A G E N D A

Architectural Review Board

March 28, 2023 – 5:30 p.m.

87

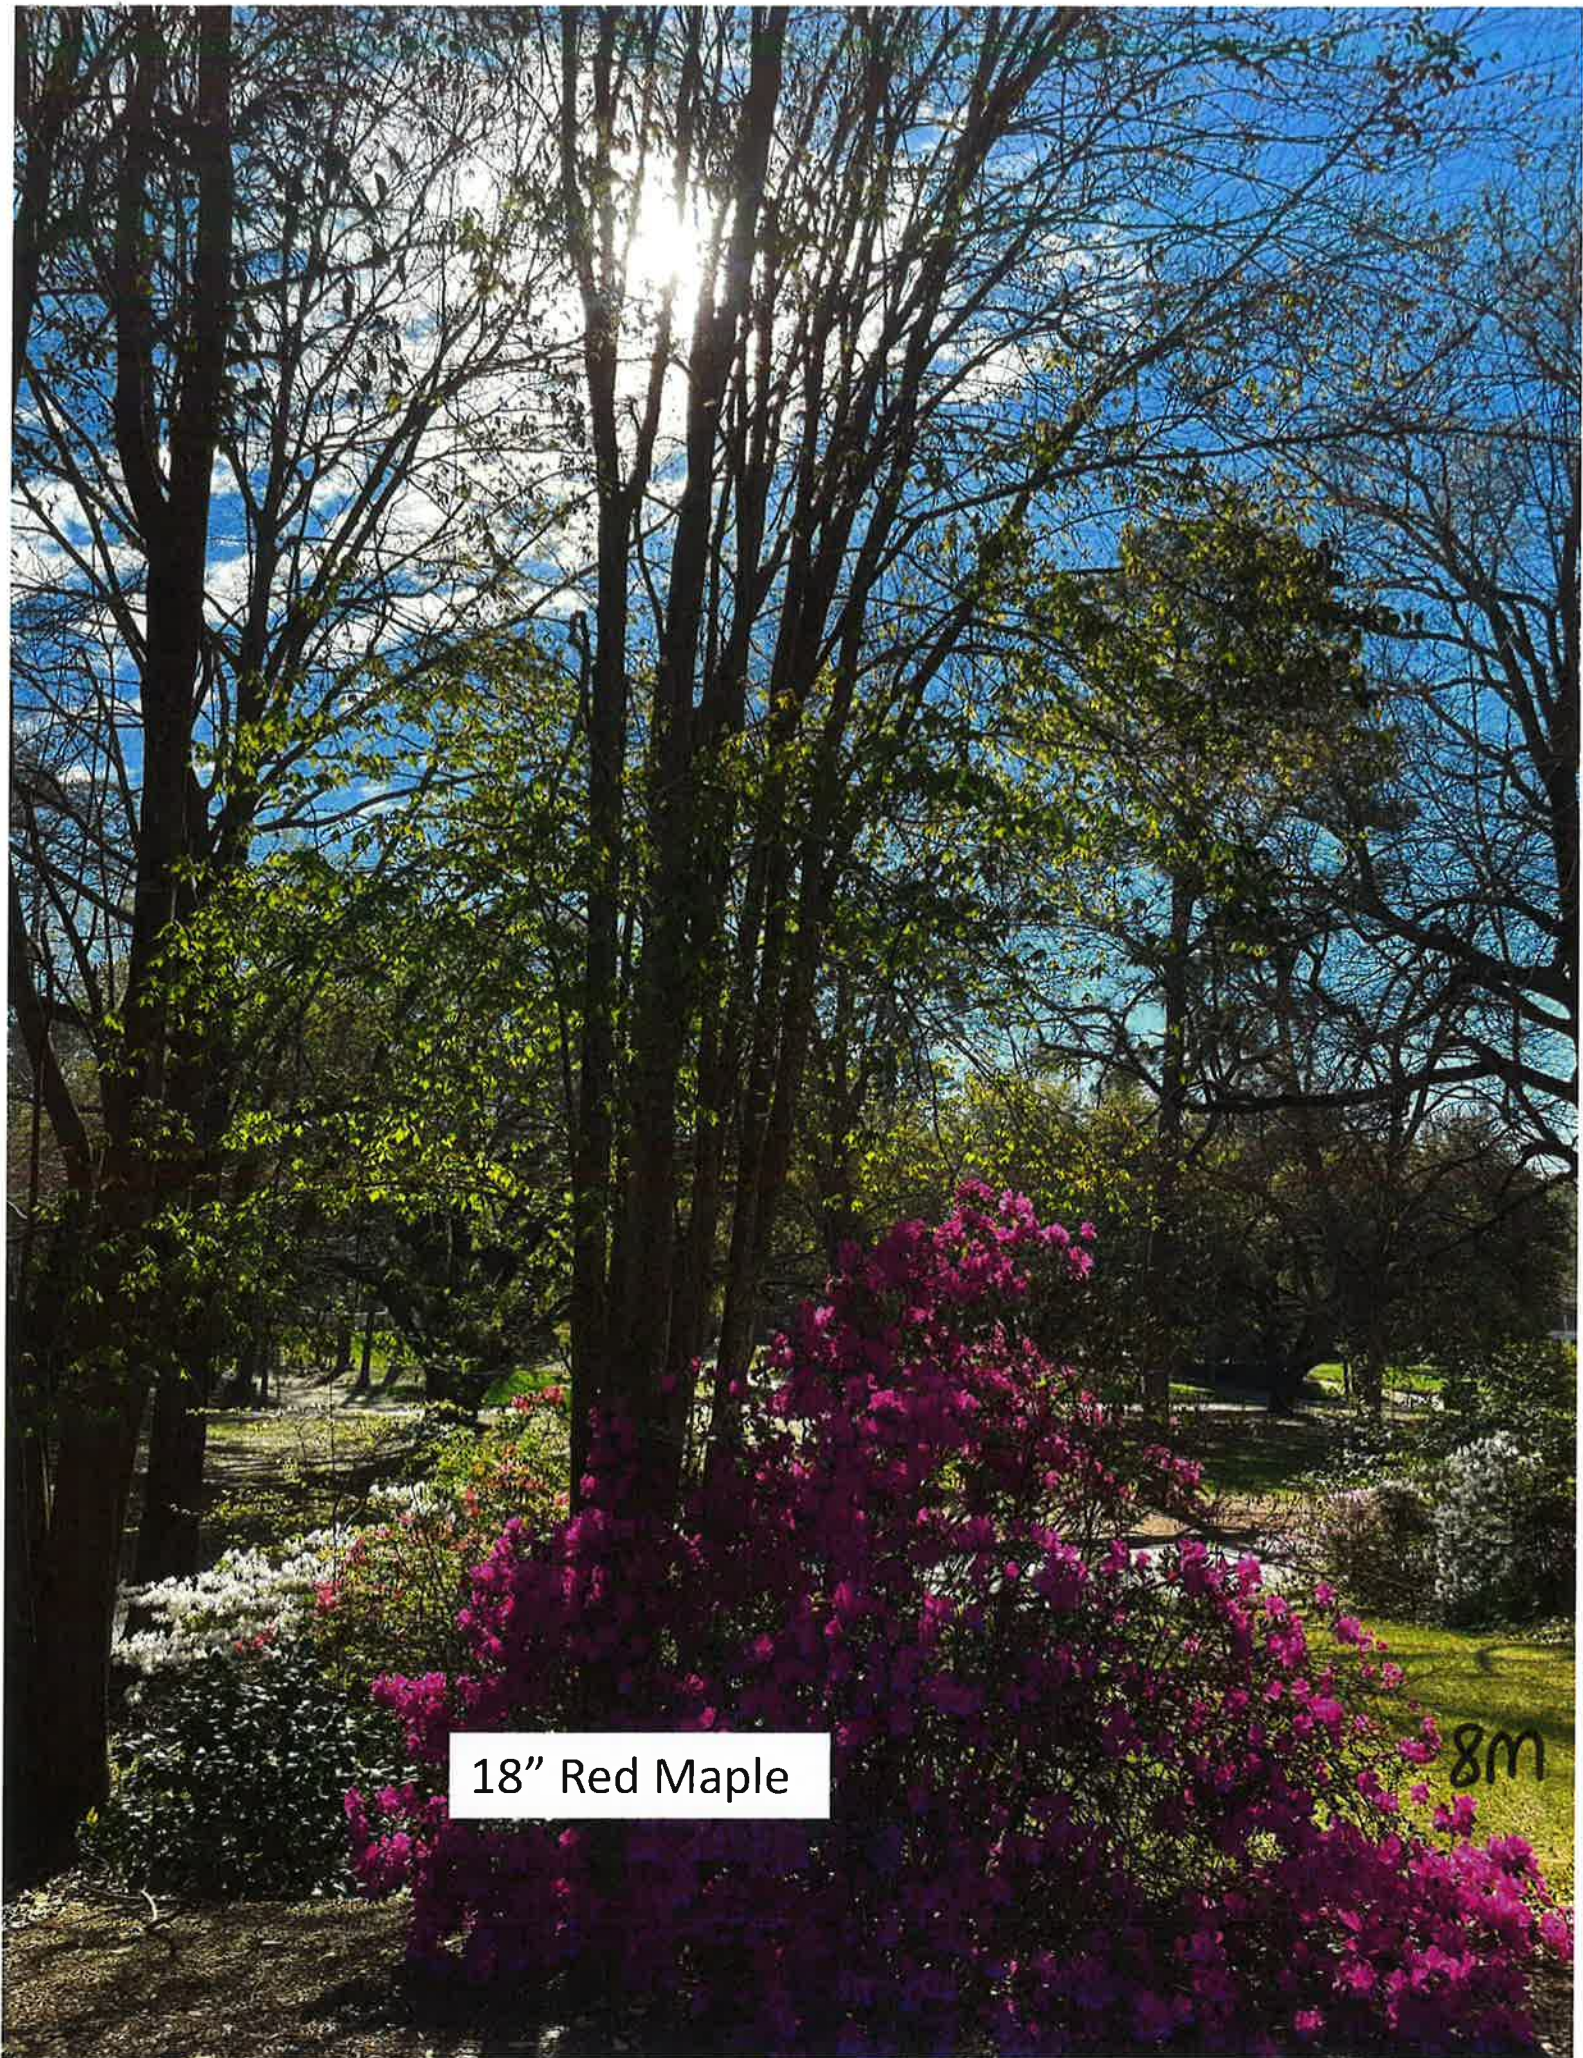
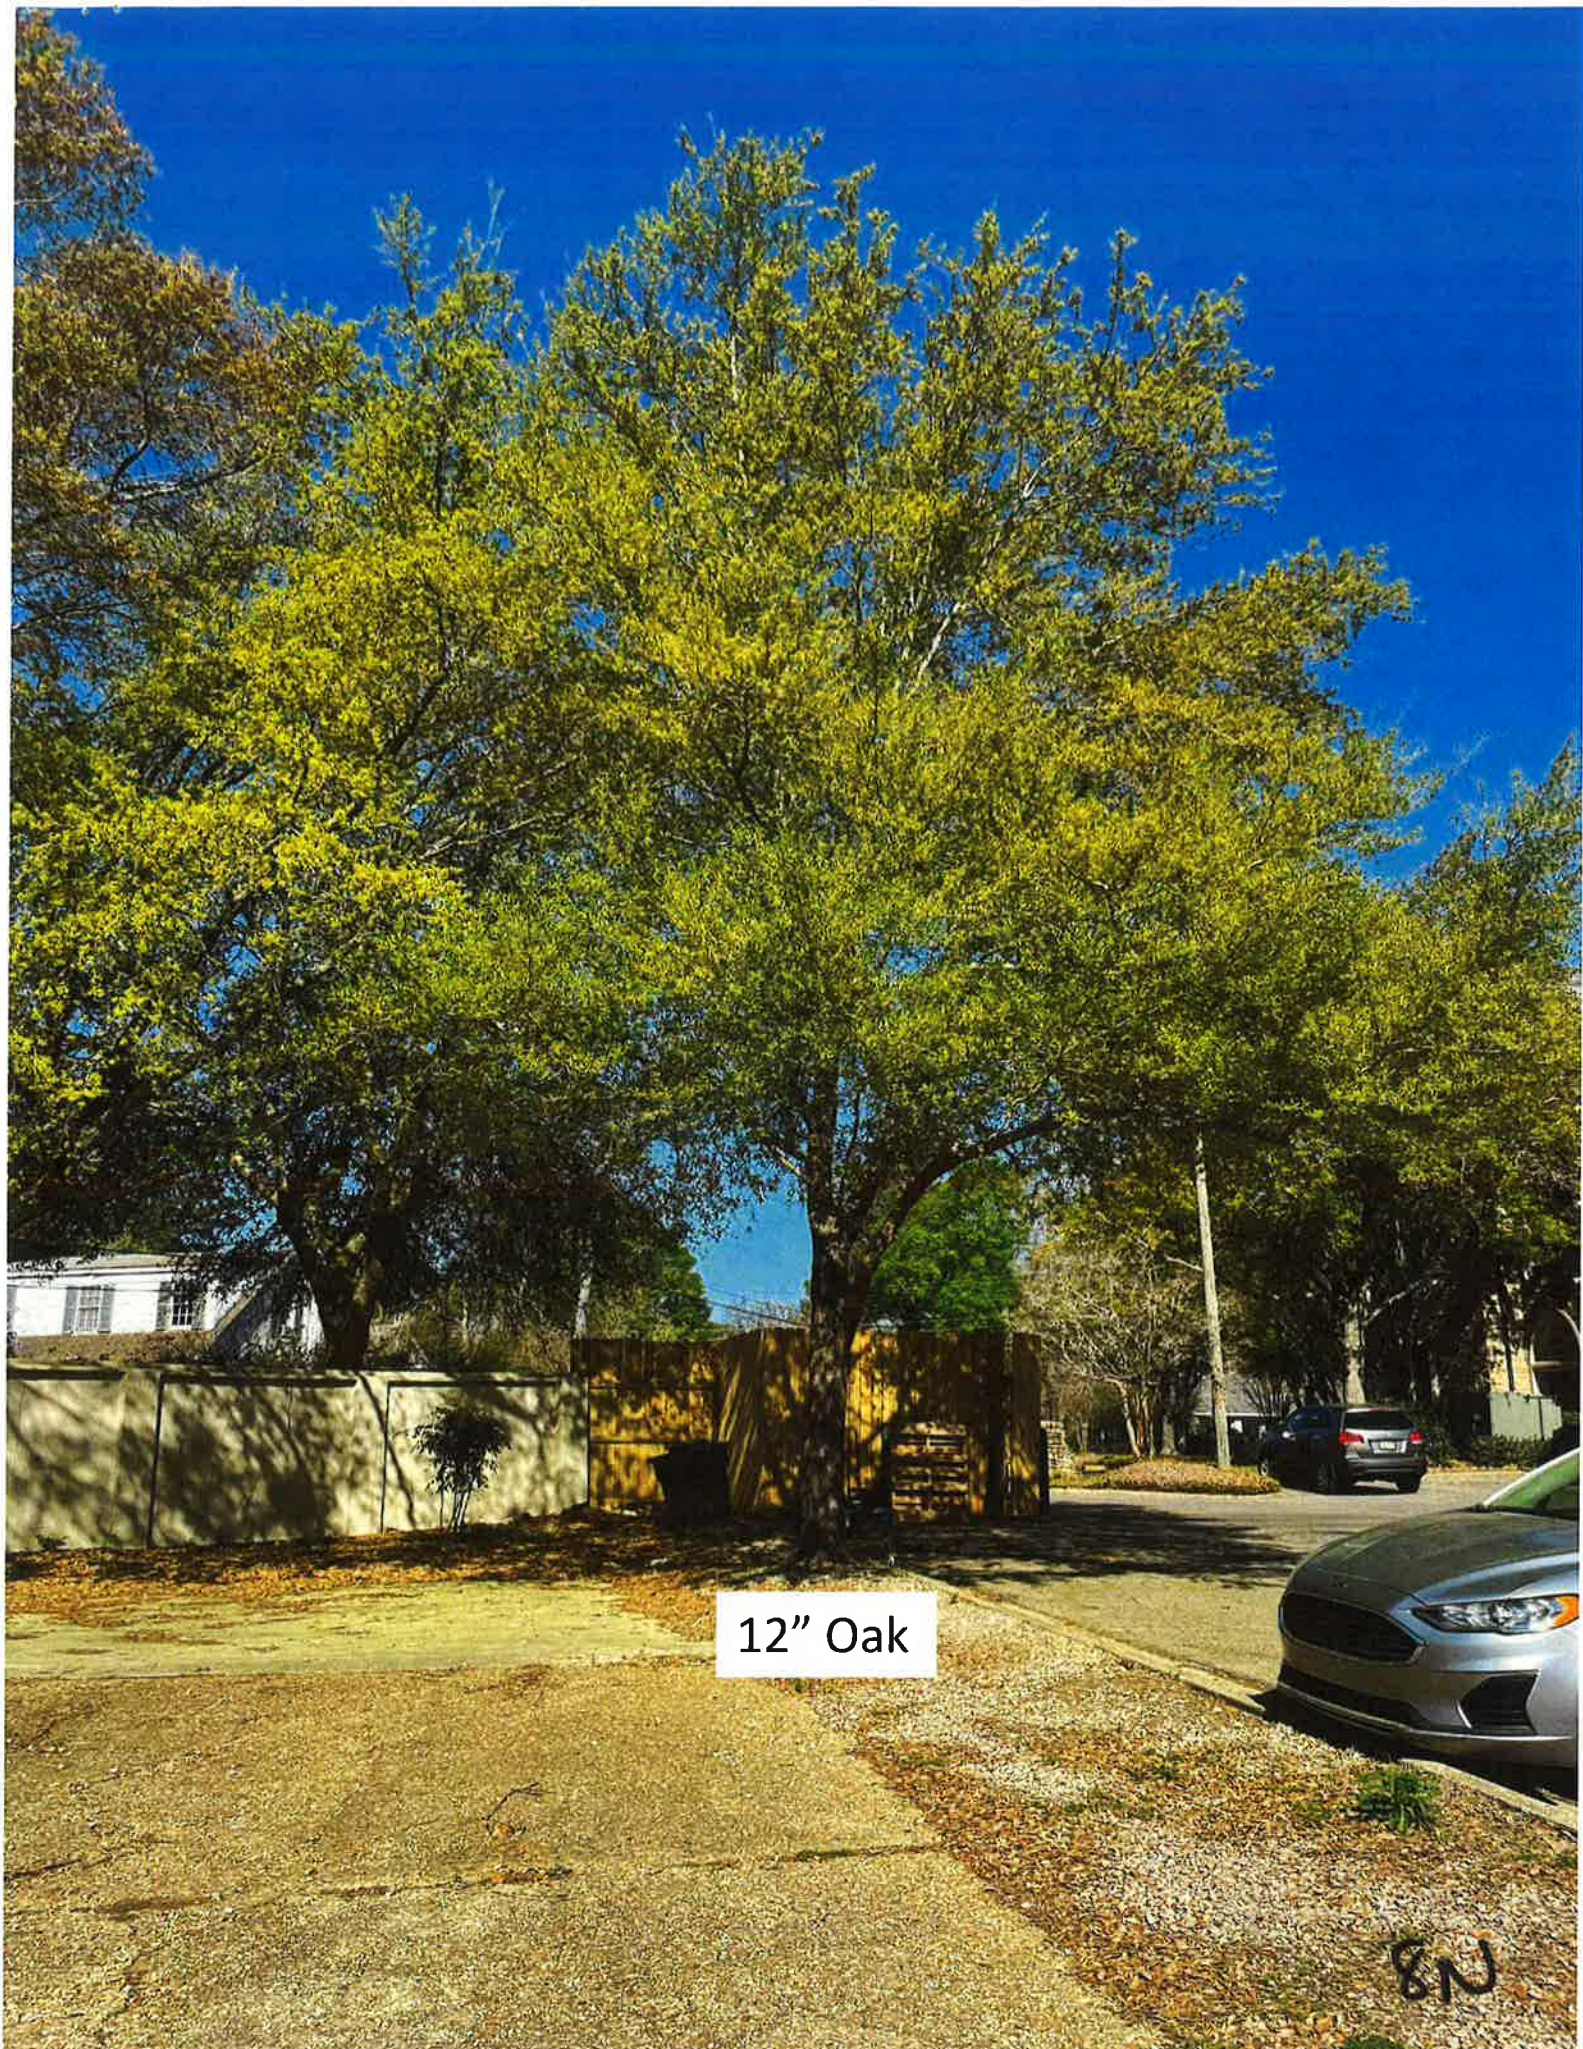
- Parking as proposed will be nearly invisible from the street.
